SERVICE BULLETIN

SB1278

ADDRESSEES	: ABC Customer Care and Parts Source Owners and operators of coaches listed under 'Application'
VEHICLE MODEL	: TD925US with steered trailing axle
MANUAL SECTION	: Chapter 07.10: Trailing axle steering system
BULLETIN TYPE	: Field Change Program
DATE	: May 4th, 2015
SUBJECT	: To replace pivot bearing of hydraulic steering cylinder and greasing recommendations
TERMS & CONDITIONS	: Refer to the warranty section further in this Bulletin.

Figure 2: Valve block of trailing axle steering system (in step well of luggage compartment)

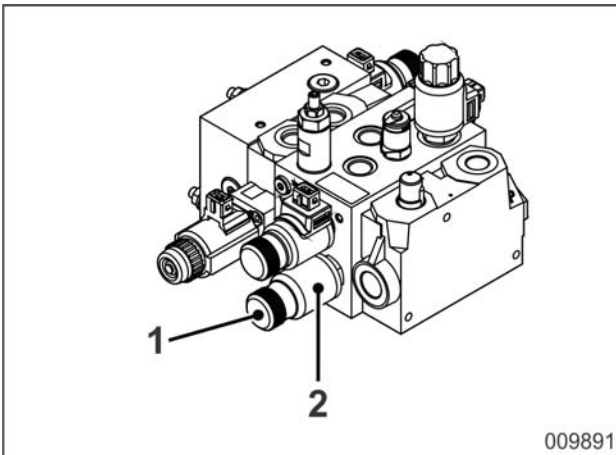
Step	Action
1	Disconnect the pressure relief valve connector.
2	Unscrew pressure relief valve end cap (1).
3	<p><i>NOTE: Make sure not to lose the O-ring when removing the coil.</i></p> <p>Remove pressure relief valve coil (2).</p>
4	<p>Screw on end cap (1) until you feel a firm resistance.</p> <p>The pin at the end cap inside now opens the pressure relief valve.</p>
5	<p>Check on the pressure gauge whether the pressure has fallen down.</p> <div data-bbox="571 1061 1198 1518" data-label="Image"> </div>
